## **AMENDMENTS TO THE SPECIFICATION**

### **AMENDMENTS TO THE DRAWINGS**

## **REMARKS**

Fig-20

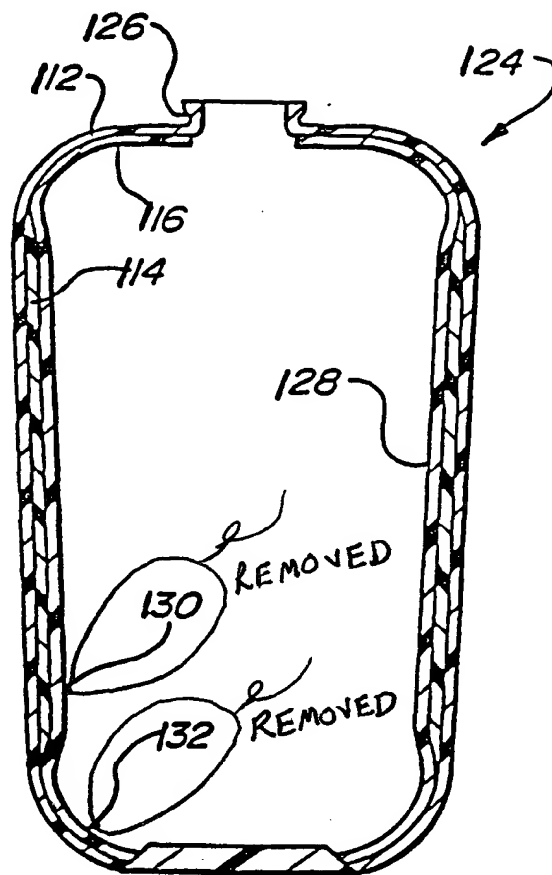
Reference signs 130 and 132 appear in Figure 20 but are not mentioned in the description. Reference sign 170 appears in Figure 21 but is not mentioned in the

description. Applicants present replacement figures in which reference signs 130, 132, and 170 have been removed.

The attached sheets of drawings include changes to Figures 20 and 23. The attached sheets, which includes Figures 19-23, replace the original sheets including Figures 19-23.
